Re: Petition No. 1286
West Brookfield Reliability Project – Development & Management Plan

ATTACHMENT A

WEST BROOKFIELD 14H
YARD EXPANSION - GRADING & EROSION CONTROL
CIVIL PLAN
BROOKFIELD, CT

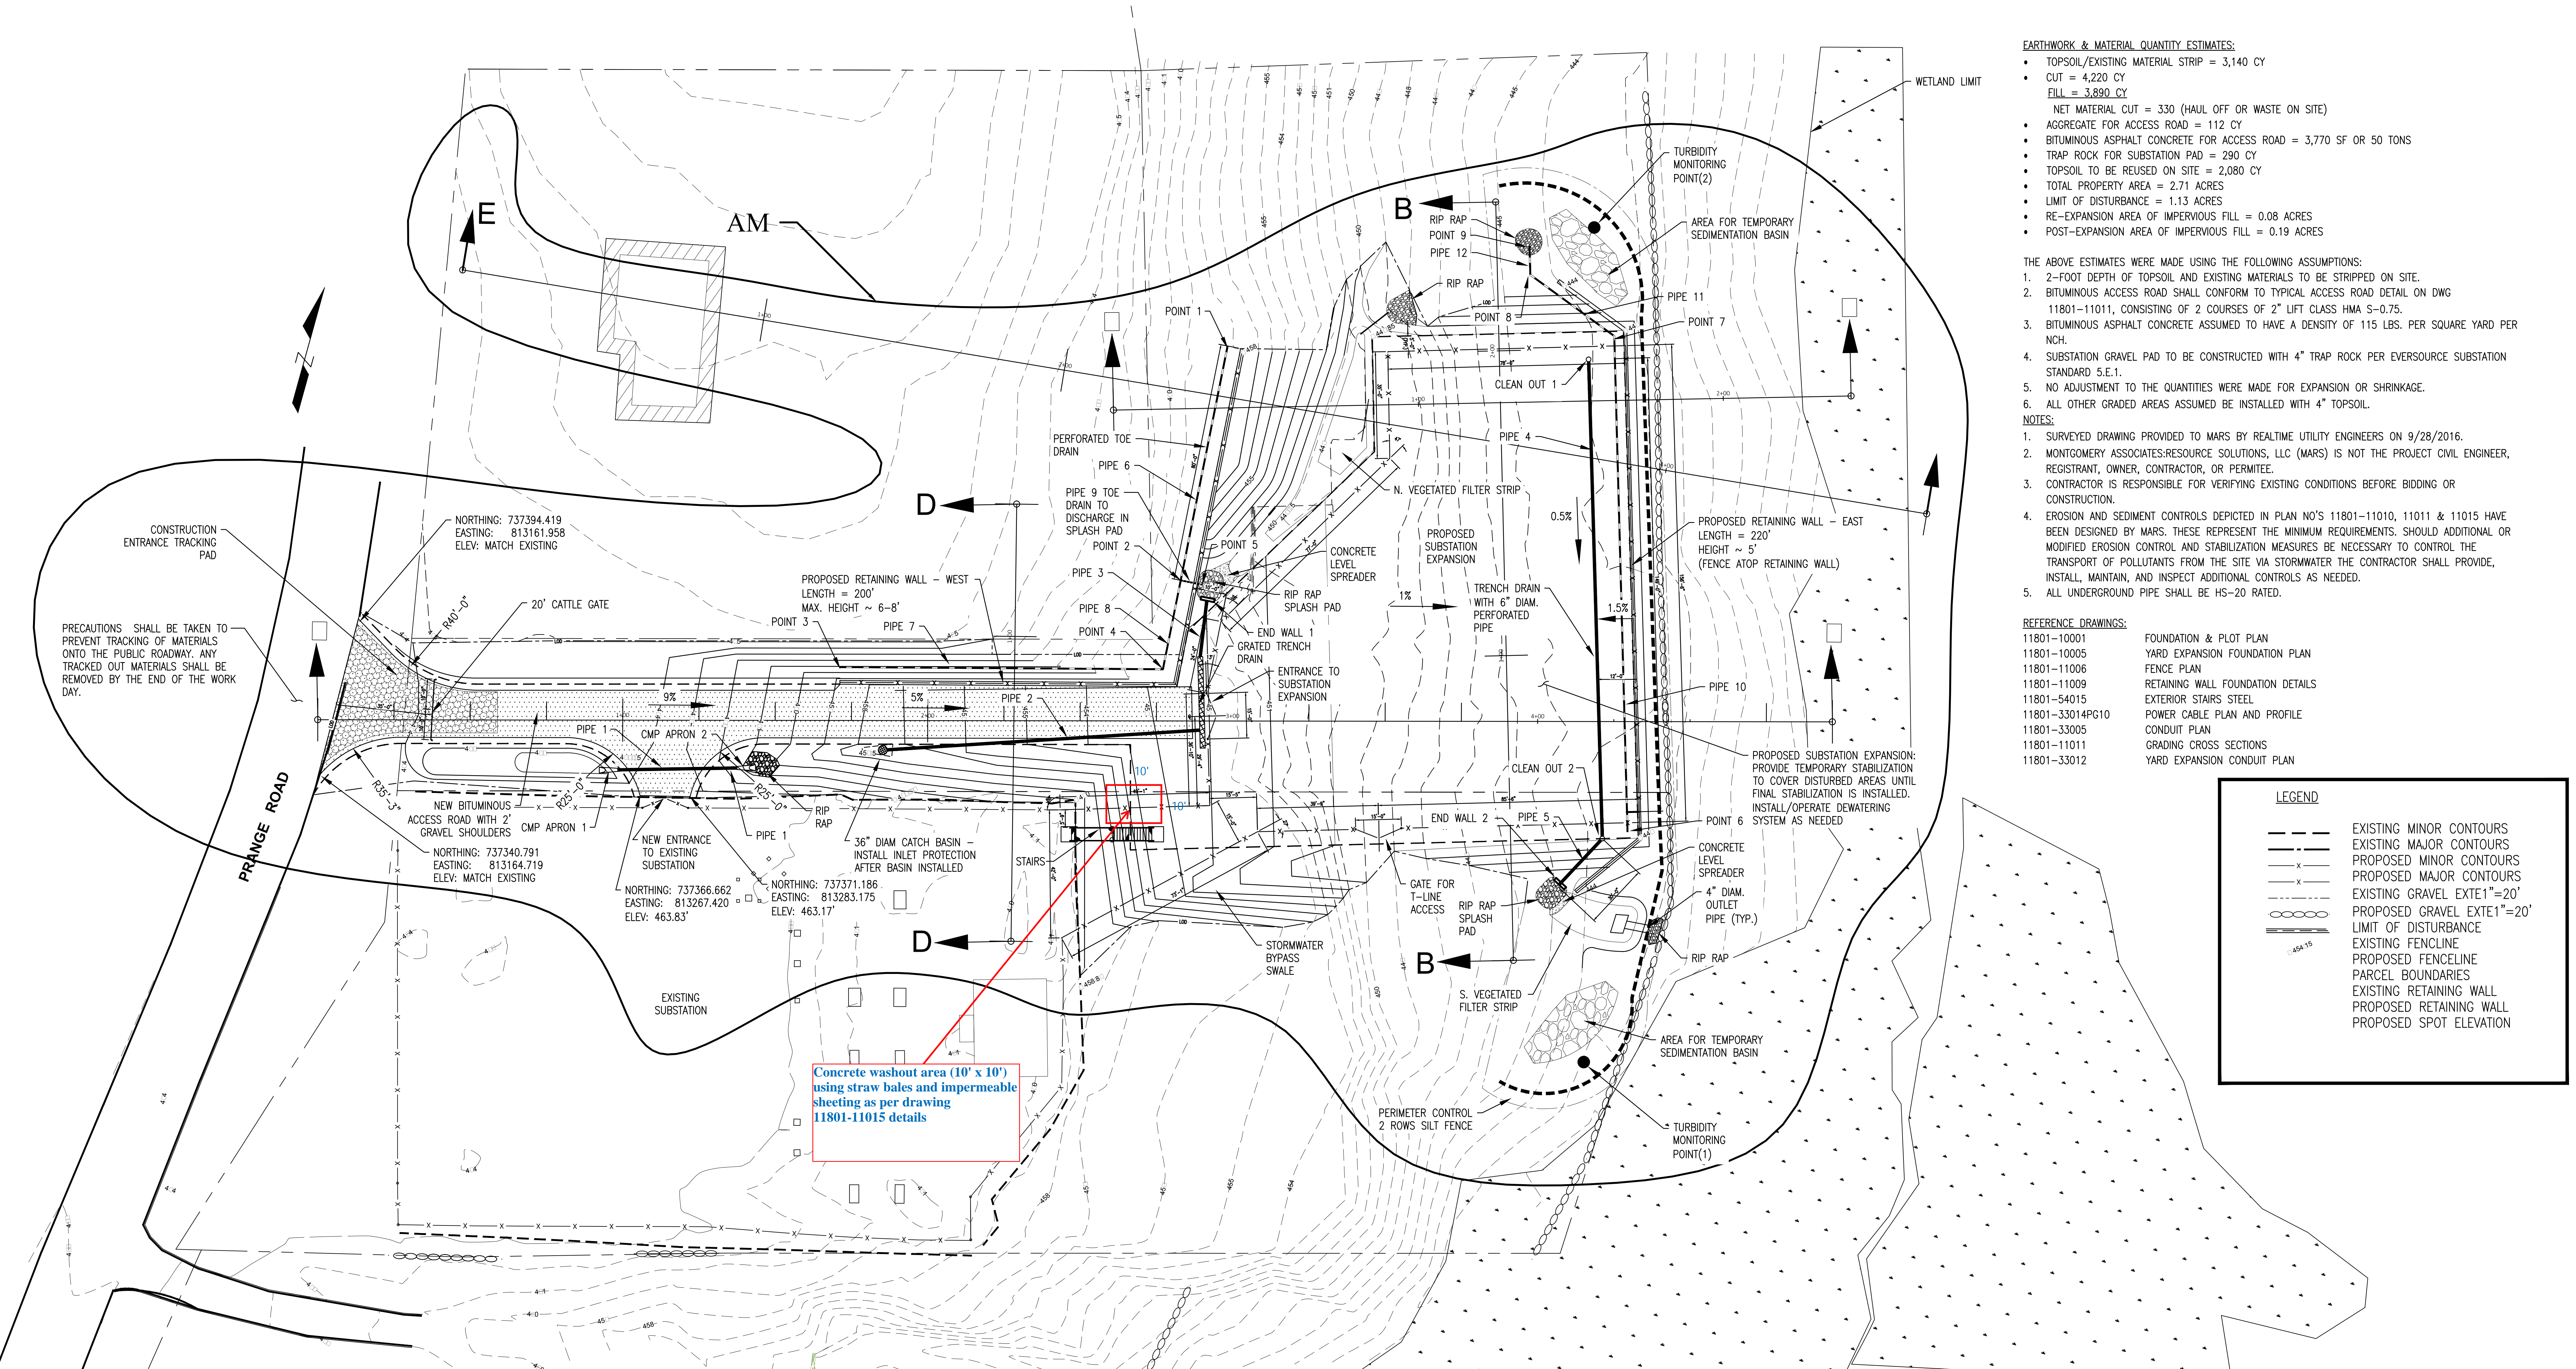
The concrete washout station is located near the northeast corner of the existing substation, as shown on the attached revised Yard Expansion – Grading and Erosion Control Plan, Drawing No. 11801-11010 (Attachment A). The washout structure has an inside dimension of 10’x10’x3’, fitted with impermeable sheeting. It is constructed per the “Washout Structure with Straw Bales” detail and the construction specifications shown on attached Drawing No. 11801-11015 (Attachment B). The original Drawing No. 11801-11010 and Drawing No. 11801-11015 had also been included in the Development & Management Plan submitted to the Council.

Concrete washout area (10' x 10') using straw bales and impermeable sheeting as per drawing 11801-11015 details
